Steering Head Screw
Models: M.Y. 2010 Multistrada 1200 (all versions)
Recall Bulletin RCL-10-003

Date: Monday, July 26, 2010
To: Dealer Principal, Service Manager, North American Dealer Network
From: Austin Gray, Technical Director; Jonathan LaForte, Technical Manager

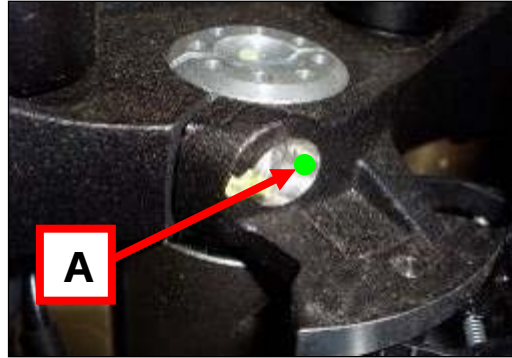
- On a production lot, an M8x25 8.8 screw has been incorrectly installed onto the steering head instead of the required M8x28 10.9 screw.

- The frames listed in the above table need to be modified immediately by recalling the motorcycles delivered to final customers or during the pre-delivery operations.
- Replace the steering head screw with the above-mentioned M8X28 10.9 screw, **Part. No. 771.5.726.8C**, and tighten to **18 Nm $\pm$ 5%** with graphitized grease.
- After such intervention, use an indelible green felt pen and draw a dot in a visible position on the steering head (A) to indicate that the modification was carried out.

- Replace the steering head screw with the above-mentioned M8X28 10.9 screw, **Part. No. 771.5.726.8C**, and tighten to **18 Nm $\pm$ 5%** with graphitized grease.
